PUBLIC INTEREST REVIEW FOR GROUNDWATER APPLICATIONS

TO: Water Rights Section Date 04/26/2016
 FROM: Groundwater Section Phillip I. Marcy
 SUBJECT: Application G- 18266 Reviewer's Name
 Supersedes review of _____ Date of Review(s)

A. GENERAL INFORMATION: Applicant's Name: Stephen Montecucco County: Clackamas

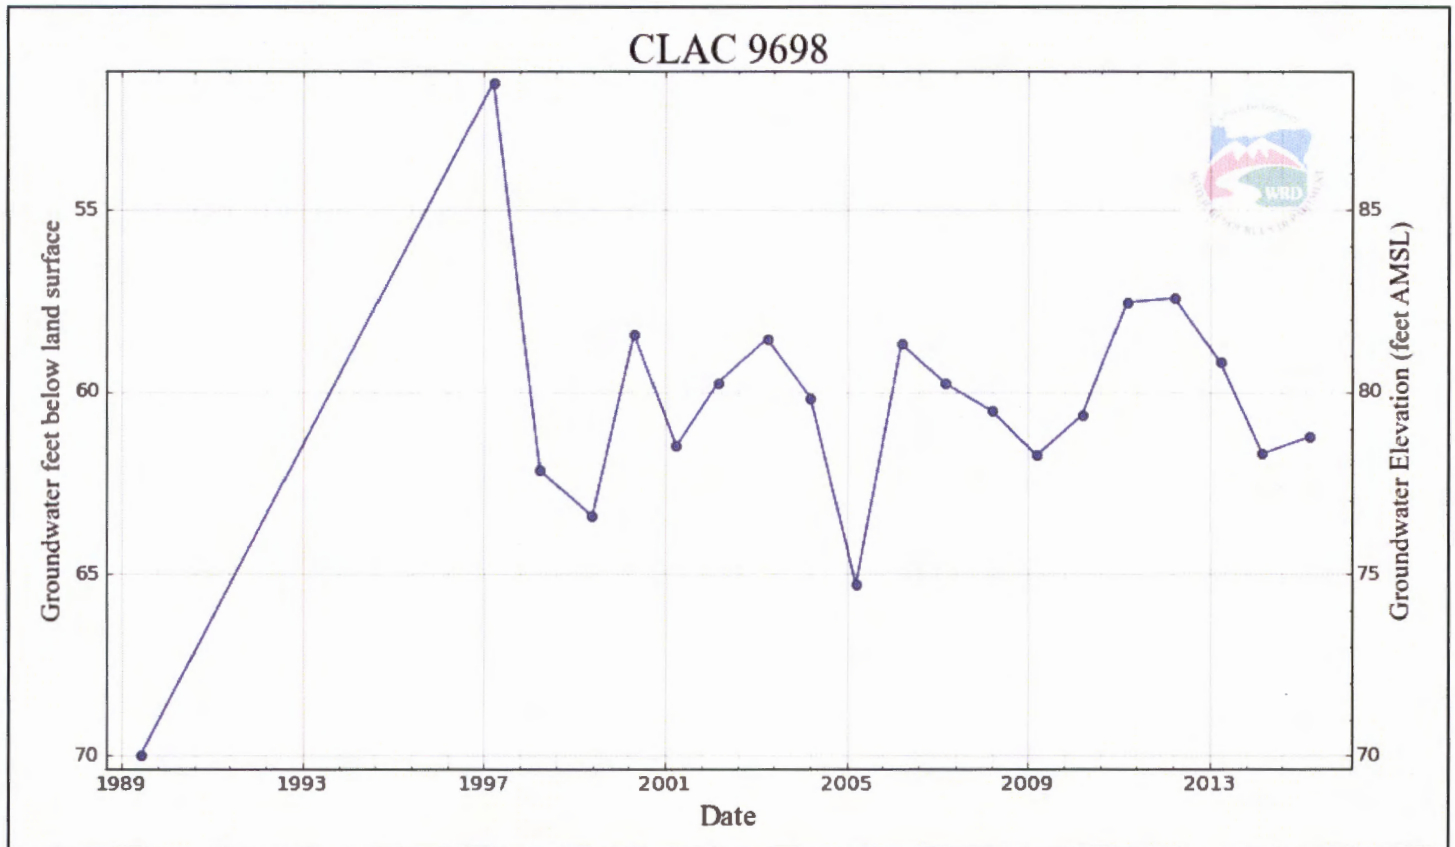
B3. **Groundwater availability remarks:** Nearby irrigation well CLAC 9698 appears to produce from the proposed aquifer system on this application, and water level data show this system to be relatively stable on an annual basis (see attached hydrograph). Therefore, further development of this aquifer system will not likely injure the rights of senior groundwater users in the area or impair the long-term stability of the groundwater resource here. If a permit is issued, the conditions set forth in B1 and B2 shall be applied to ensure that the Department has the ability to monitor and maintain the resource.

Figure 2: Well log reports from 3S/1E - S 28 & 29 show falling head elevation with completion depth, with no indication of a confined aquifer system.

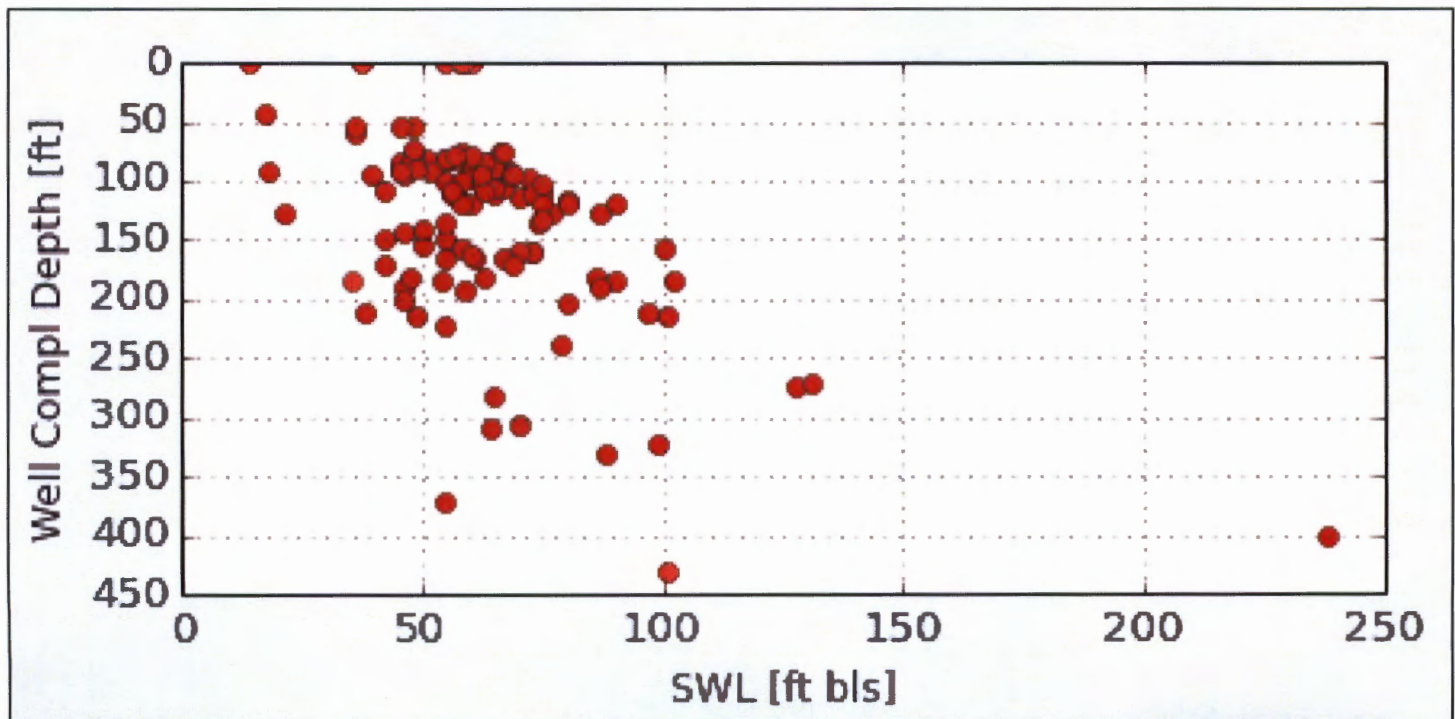
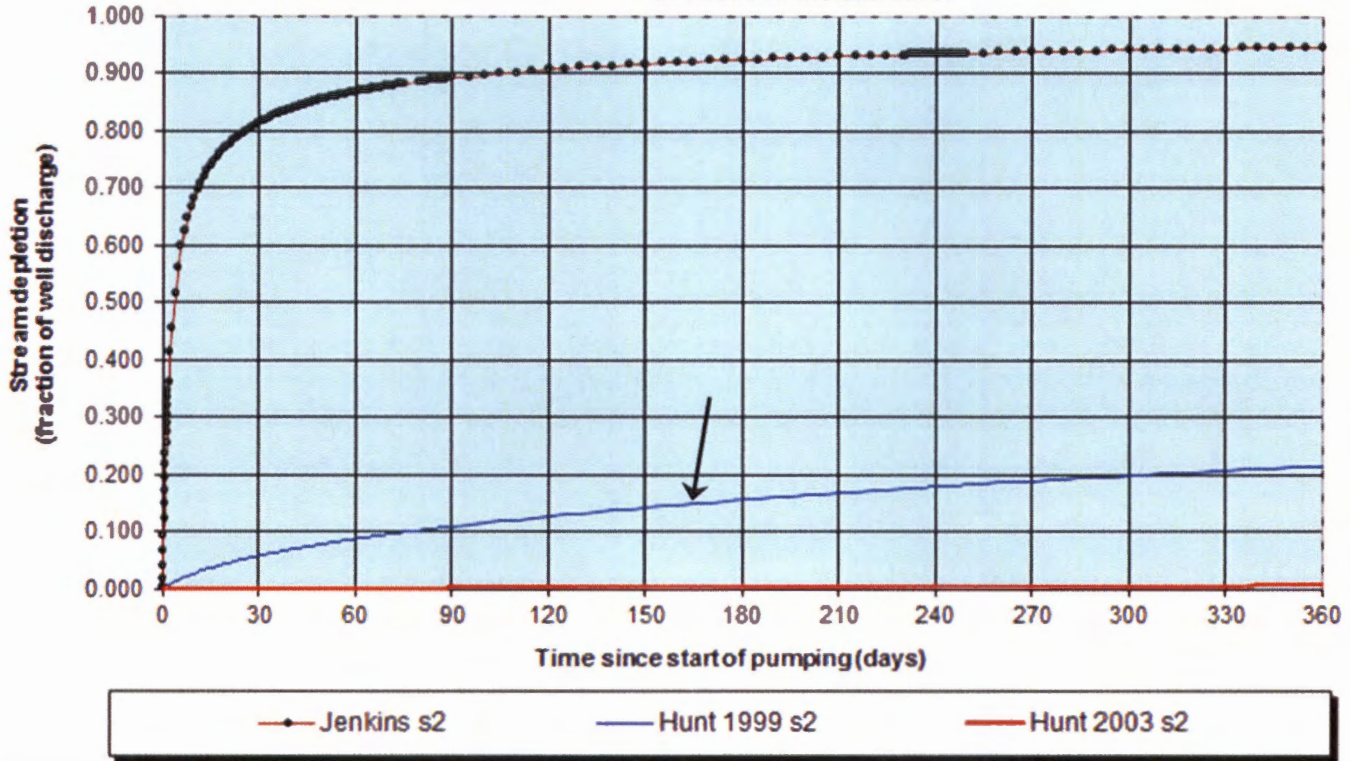
Basis for aquifer confinement evaluation: Nearby well logs do not report a significant barrier to vertical migration of groundwater, nor is there evidence for a difference in head elevation between different production zones (Fig. 2).
